Docket Item # 2
BAR CASE #2010-0293

BAR Meeting
January 19, 2011

ISSUE: Signage
APPLICANT: Capital One Bank
LOCATION: 500 South Washington Street
ZONE: CD/Commercial

Figure 2: Photo of existing, unapproved Capital One Bank signs at the Wilkes Street entrance.

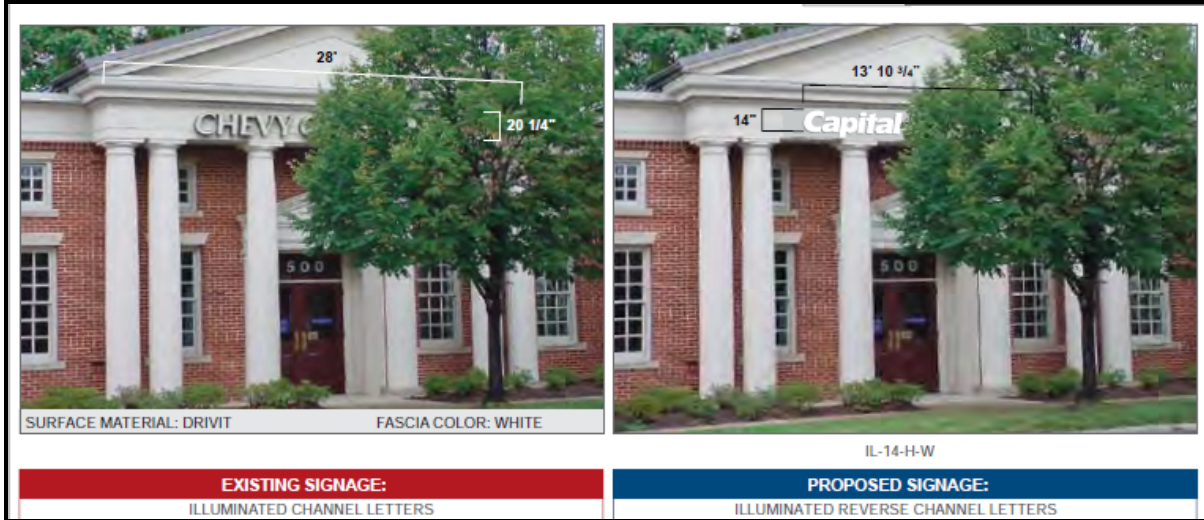
While the applicant was given clear direction that the installation of signs required BAR approval and a sign permit, the bank none-the-less installed the existing Capital One Bank signs. Staff, and the National Park Service, find these signs to be too large, too bright and generally inappropriate for this prominent Greek Revival style bank building on the George Washington Memorial Parkway. After the BAR application was submitted, the applicant worked closely with Staff and understood that the installed signs were unlikely to gain Board approval. A November 17th, 2010 letter from the National Park Service also concurred that the signs were excessive and inappropriate. However, with a few exceptions, Staff supports the revised application. The National Park Service also submitted a letter of support on January 10th, 2011, commending the applicant for the revised sign package.

1. that the existing ATM/Teller LED/neon “open” signs are removed; and,
2. that the existing and unapproved Capital One Bank signs are replaced with the approved bank signs within 60 days.

Figure 5: Previous and already installed ATM header sign – drive-thru kiosk (1).

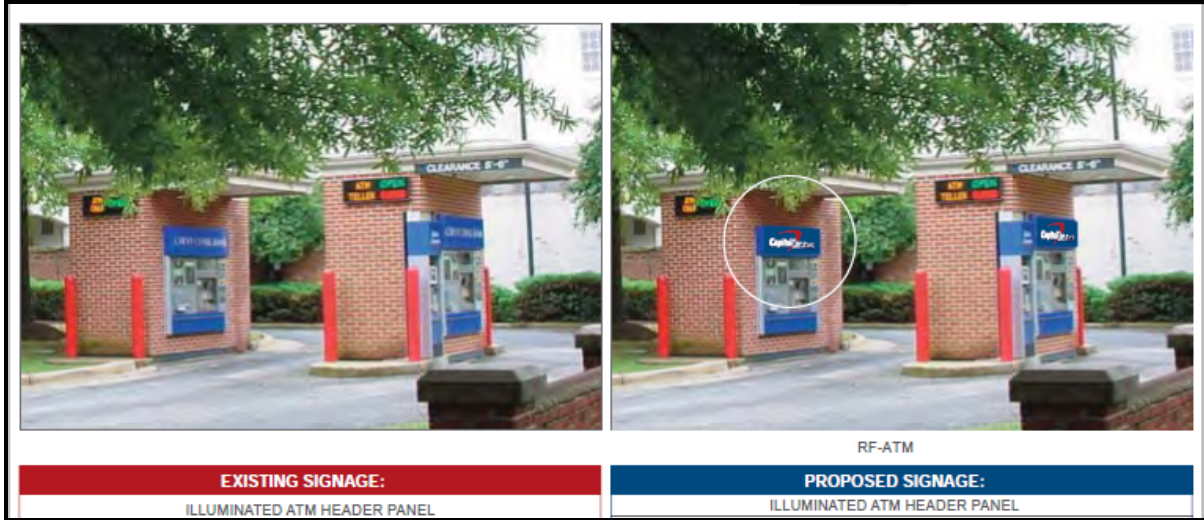
- No changes are proposed to the already installed blue clearance signs above the drive-thru ATMs, the three ATM sign bands or the door graphics.
